Access Compliance Report

Public Rights-of-Way

(Curb Ramps)

Intersection ID: 44210	Main Street: MOCKERNUT_DR	Cross Street: PINACEAL_CT	Location: NW
ADA ID: 9ACF9C5EC32D	Ramp Type: PerpDiag	Initial Pass/Fail: Fail	Overall Compliance: No
Severity Score: 10			
Codes/Mitigation Info/Possible Solution		Field Measurements/Component Compliance

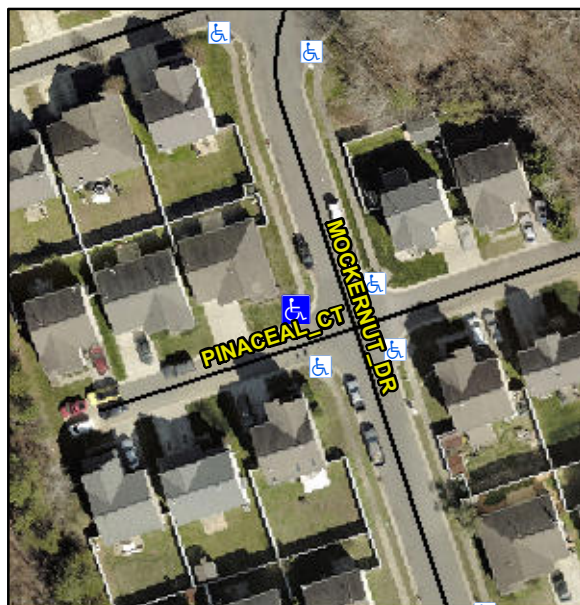
Not Found, R304.5.1, R304.5.3

Compliance	Description	Data	Compliance	Description	Data
N/A	Ramp Length (in)	50.5	Yes	Ramp Slope (%)	5.9
No	Ramp Width (in)	42.0	No	Ramp XSlope (%)	4.8
N/A	Flare Type LT	N/A	N/A	Flare Type RT	N/A
N/A	Flare Slope LT (%)	N/A	N/A	Flare Slope RT (%)	N/A
N/A	Flare Traversable LT?	N/A	N/A	Flare Traversable RT?	N/A
N/A	Landing Length (in)	N/A	N/A	DWS Provided?	N/A
N/A	Landing Width (in)	N/A	N/A	DWS Contrast?	N/A
N/A	Landing Slope (%)	N/A	N/A	DWS Length (in)	N/A
N/A	Landing X Slope (%)	N/A	N/A	DWS Full Width?	N/A
N/A	Landing Curb? (Y/N)	N/A	N/A	DWS Offset (in)	N/A
N/A	Shared Landing?	N/A			
N/A	Gutter Ponding?	N/A	N/A	Gutter Slope (%)	N/A
N/A	Gutter Lip Ht (in)	N/A	N/A	Gutter X Slope (%)	N/A
N/A	Painted X Walk1?	No	N/A	Painted X Walk2?	No
	X Walk 1 Direction	To S		X Walk 2 Direction	To E
N/A	X Walk 1 Width (in)	N/A	N/A	X Walk 2 Width (in)	N/A
	X Walk 1 Slope (%)	4.4		X Walk 2 Slope (%)	4.0
	X Walk 1 X Slope (%)	1.4		X Walk 2 X Slope (%)	4.7

Remove & Replace Curb Ramp With Two New Directional Ramps or Equivalent.
